Mayberry Filing No. 3
Traffic Technical Memorandum
PCD File No. SF2219
(LSC #S224210)
September 1, 2022

**PCD File No. SF2219
 Mayberry Filing No. 3
 (LSC#224210)
 Mayberry Drive & Springs Road Roundabout
 County: El Paso**

Figure 1
**Conceptual 120' ICD
Roundabout Parameters**

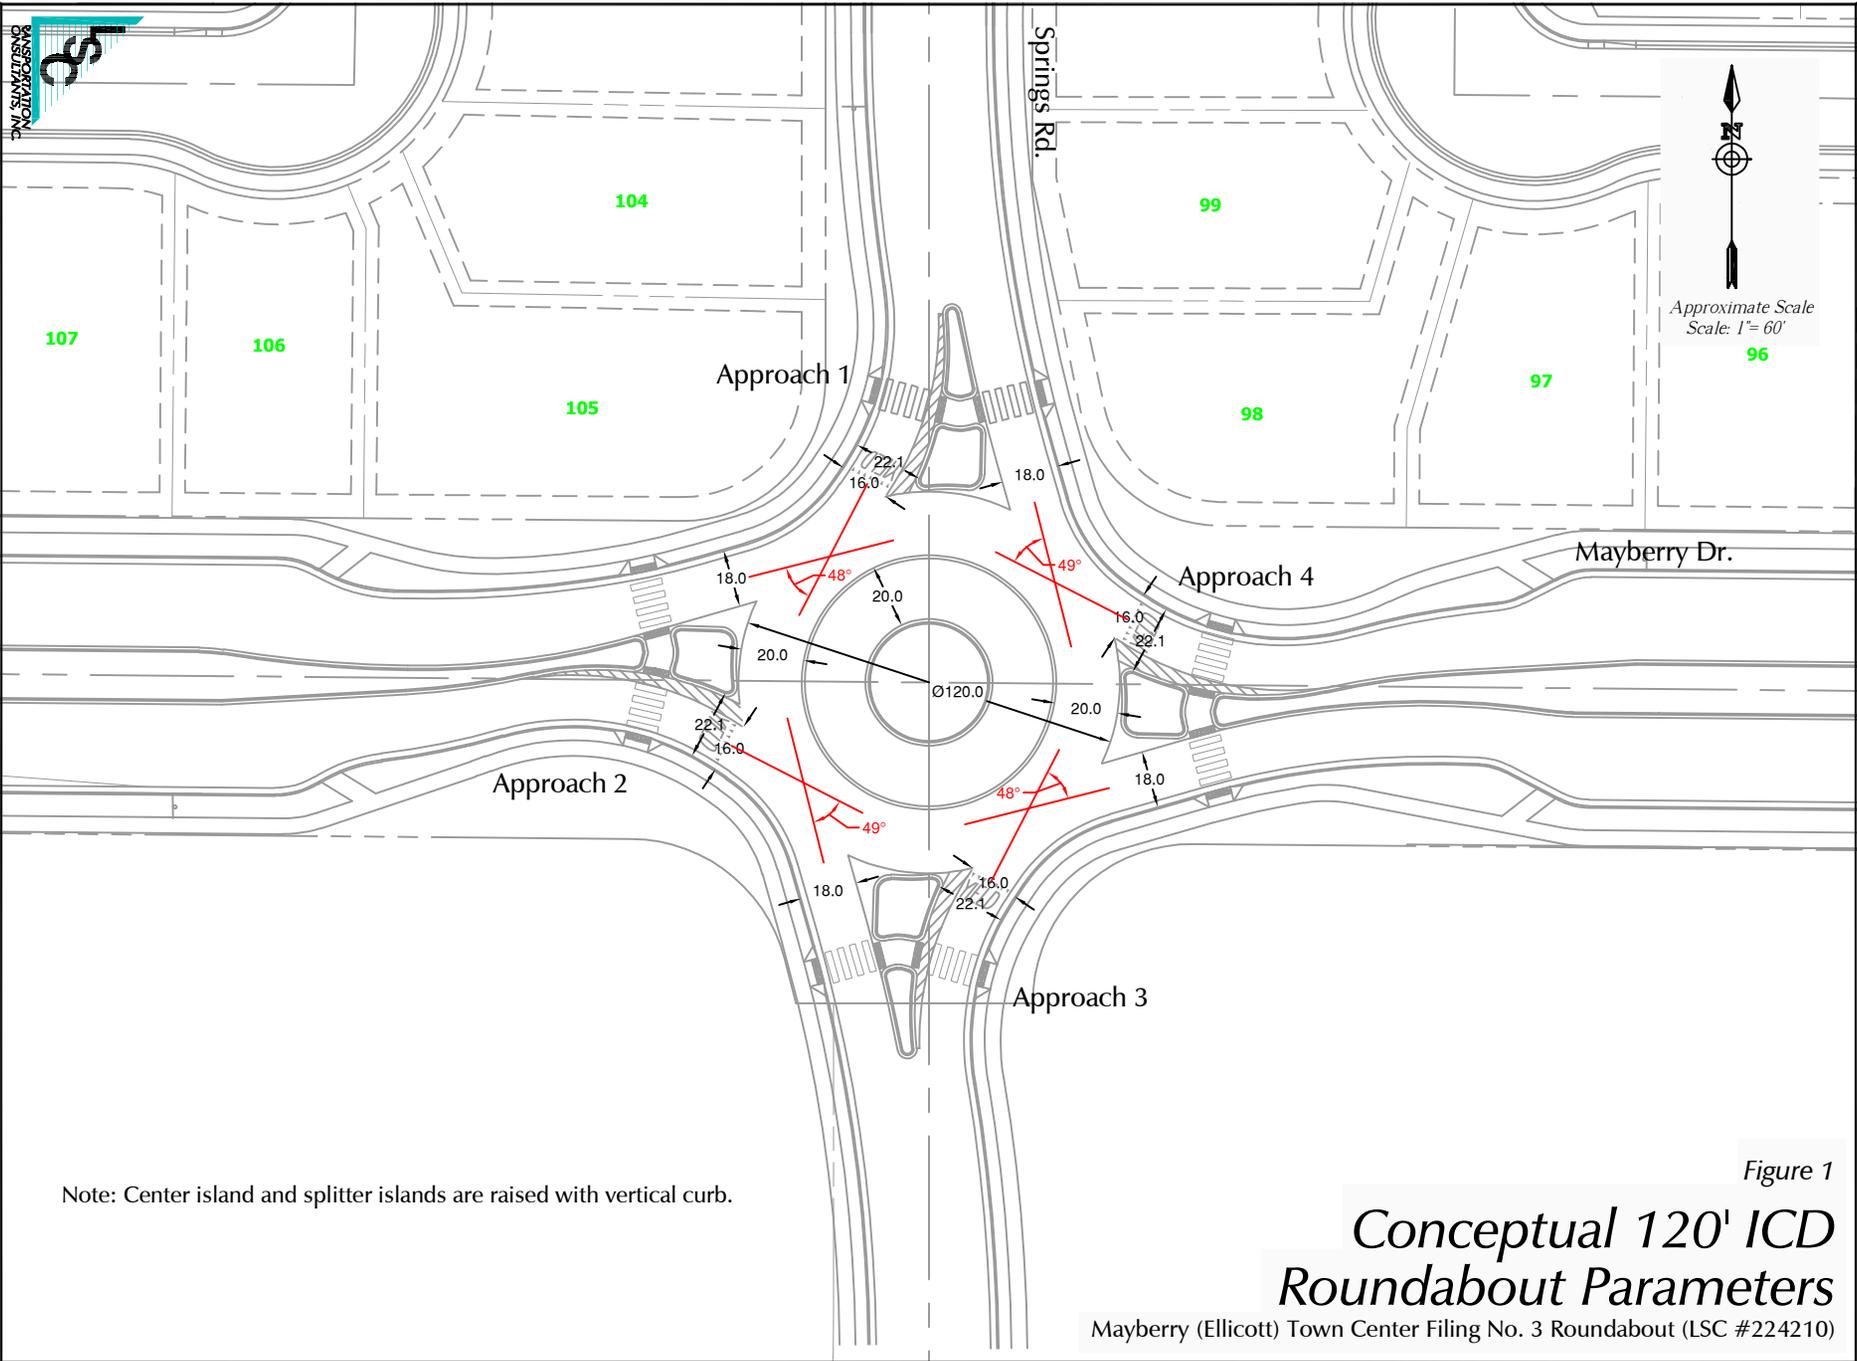
The drawing shows an entry width of 16 for each of the legs. Please clarify.

Figure 7

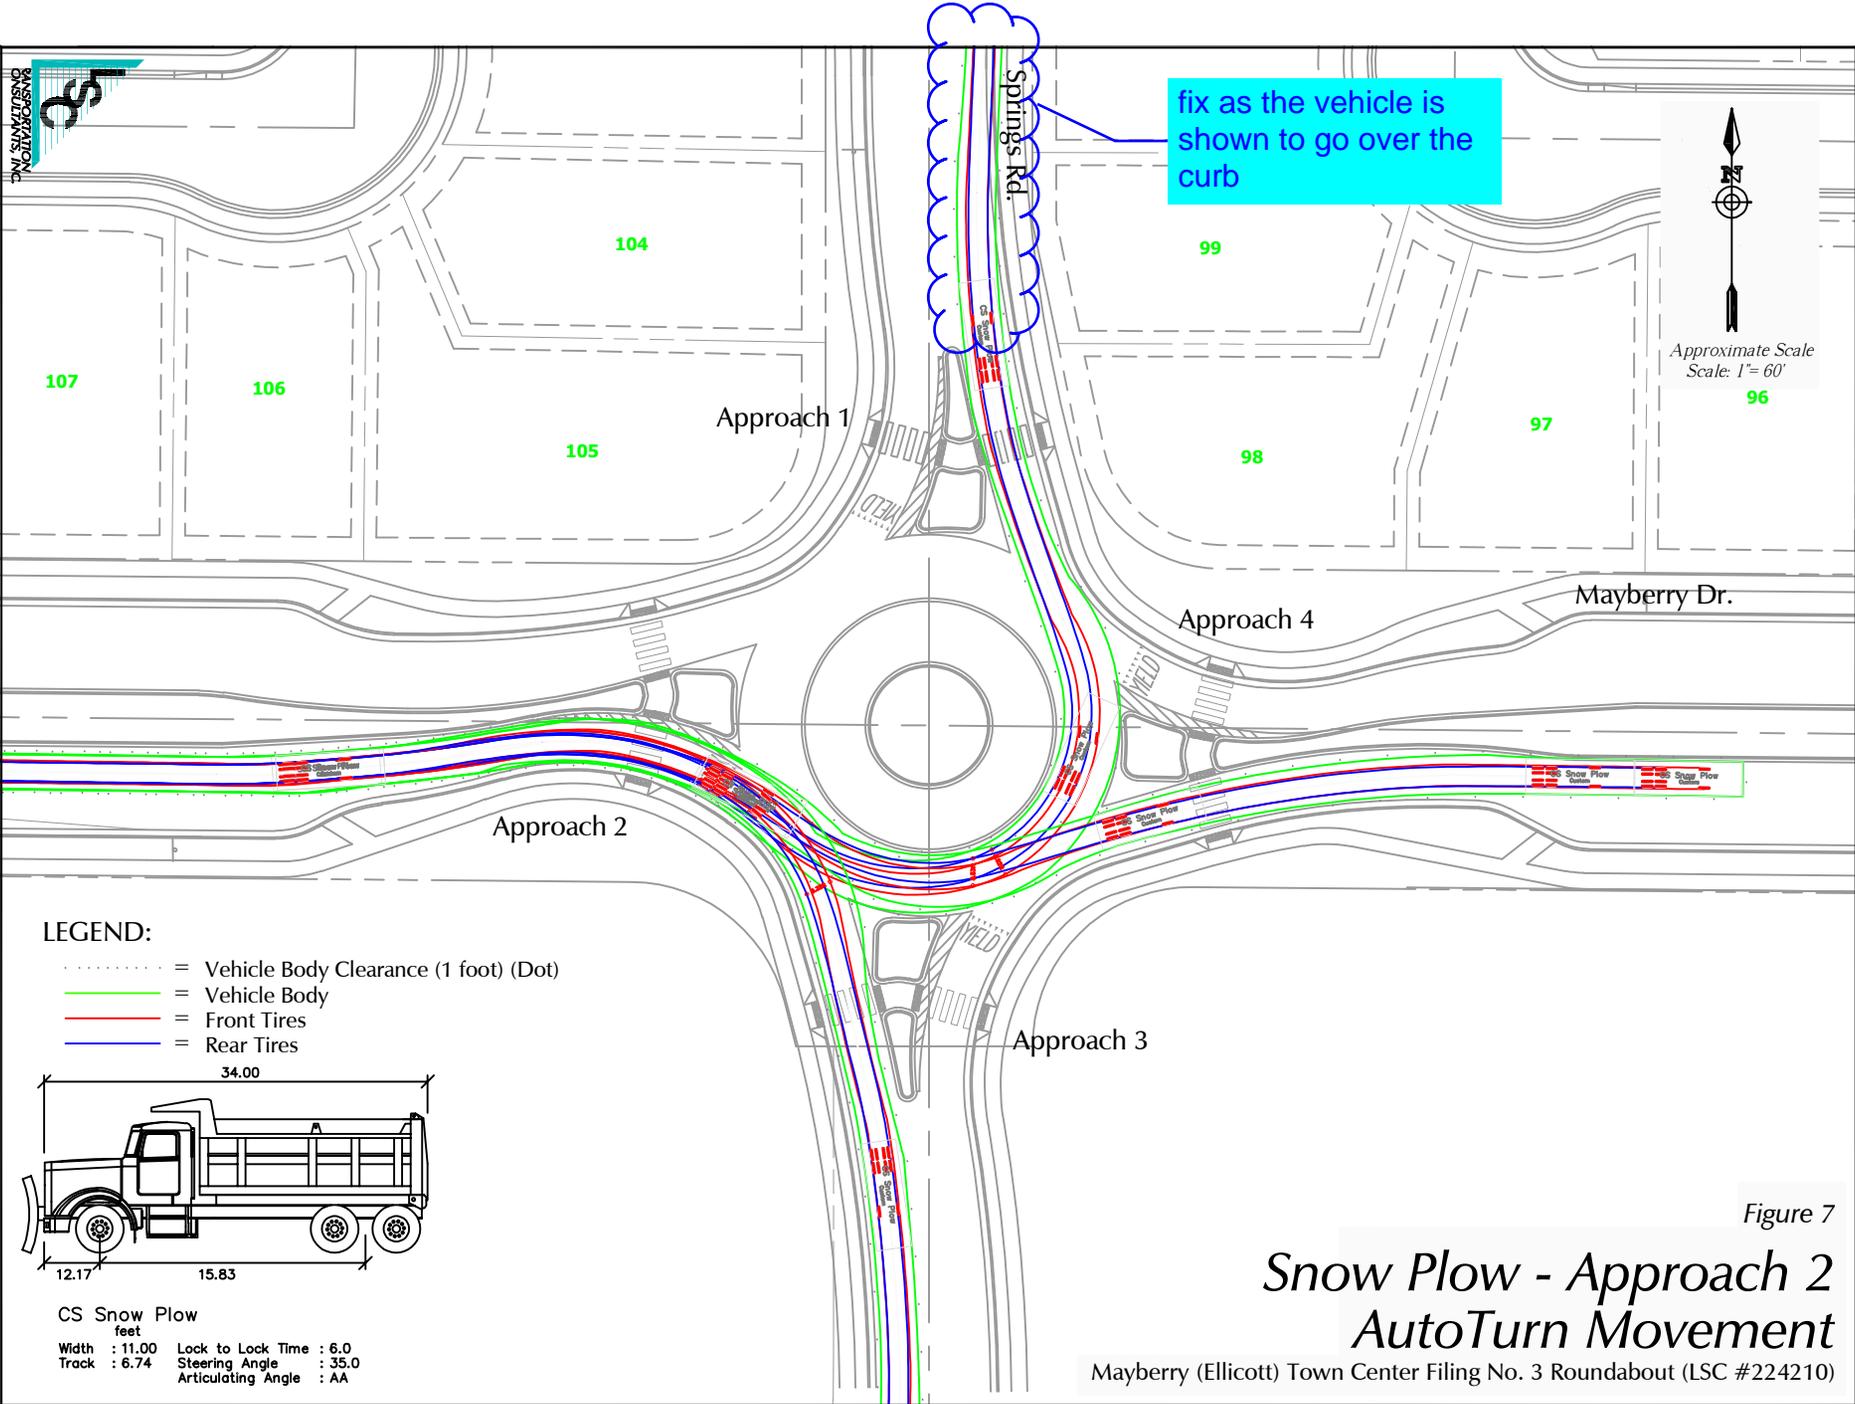
fix as the vehicle is shown to go over the curb

Figure 13
**Snow Plow - Approach 4
 AutoTurn Movement**
 Mayberry (Ellicott) Town Center Filing No. 3 Roundabout (LSC #224210)

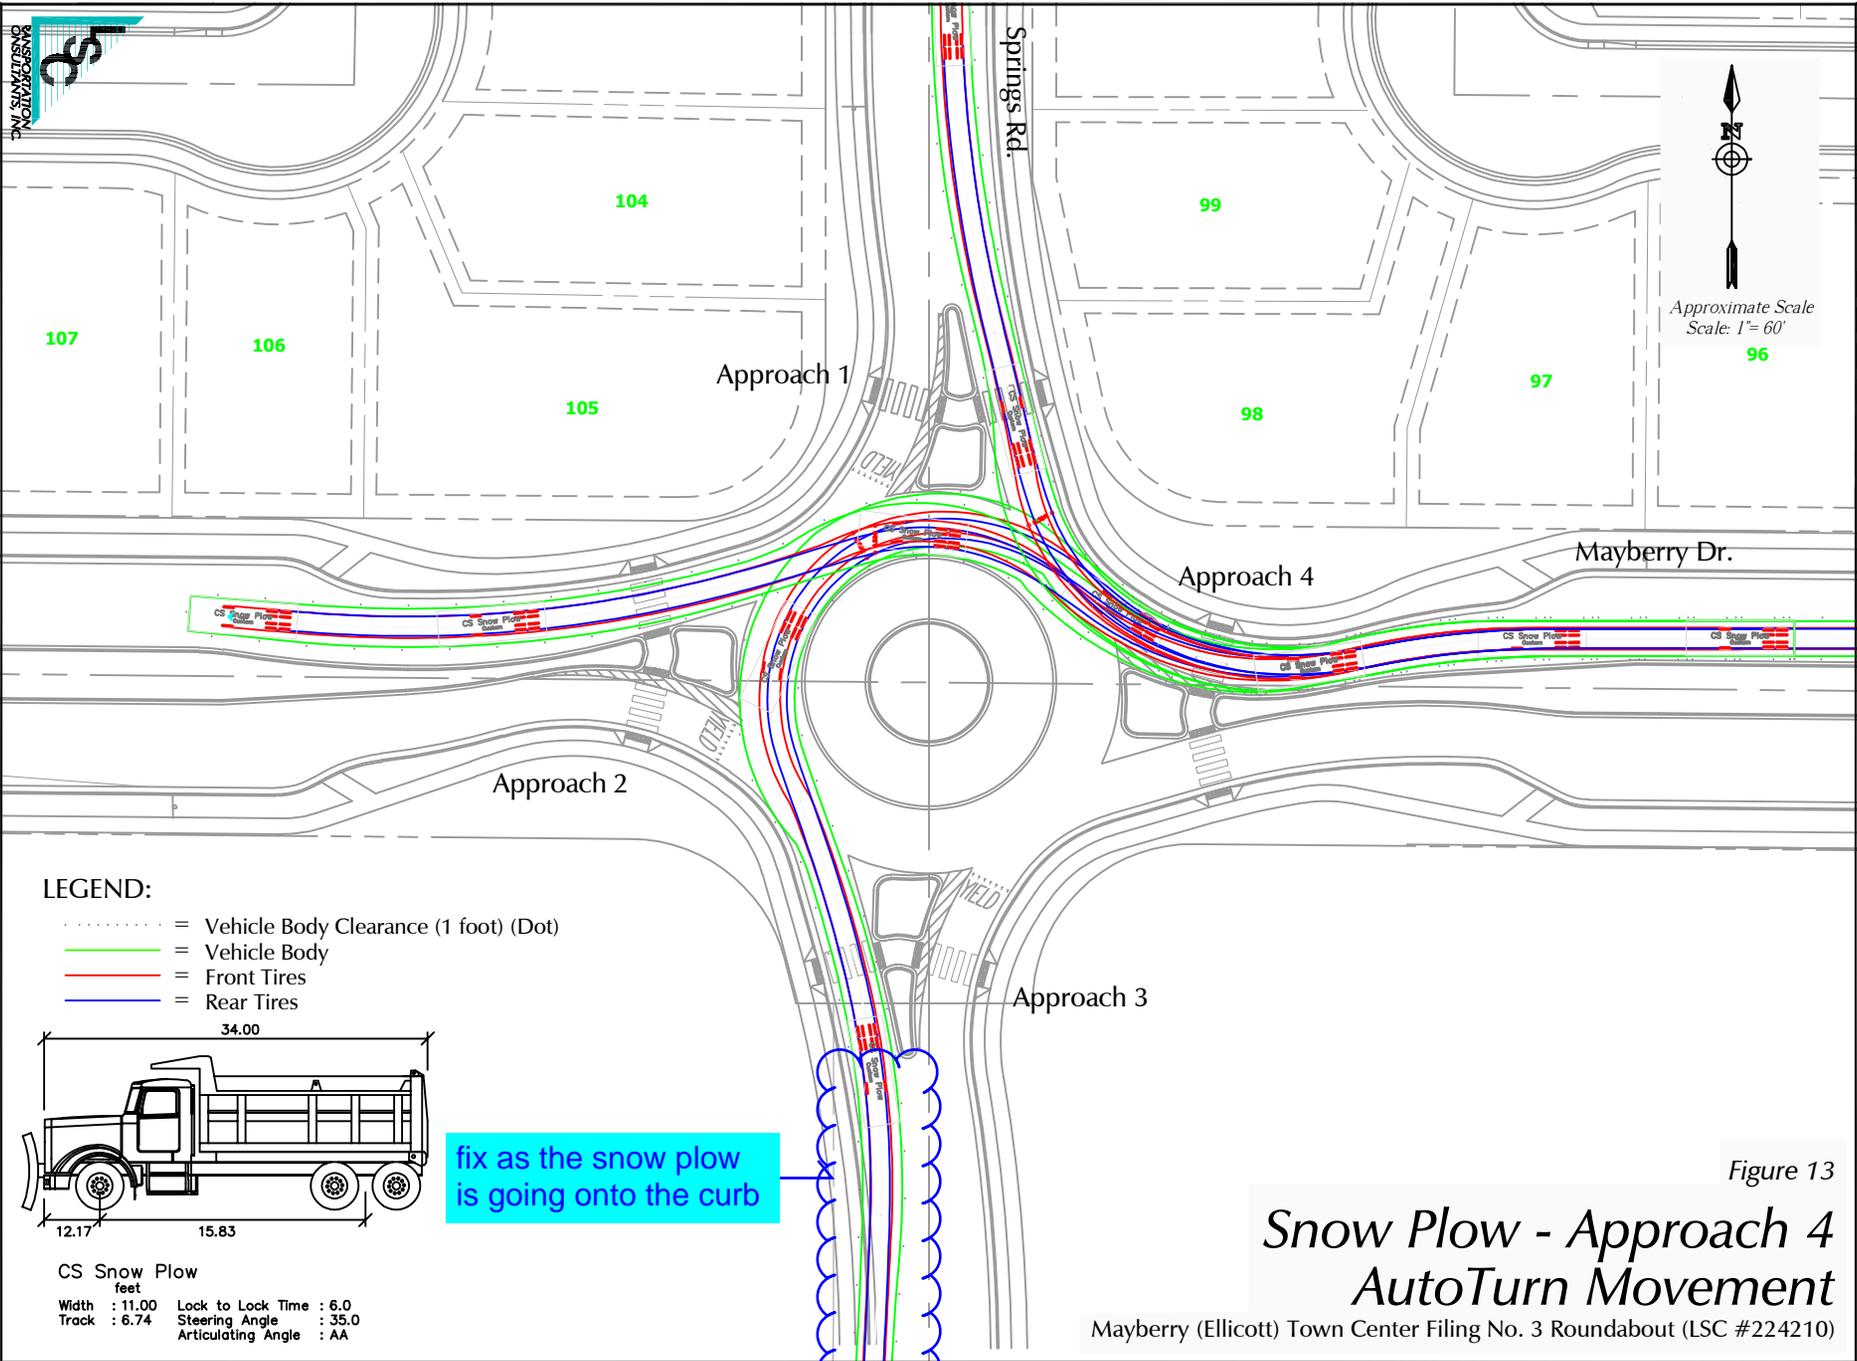
fix as the snow plow is going onto the curb
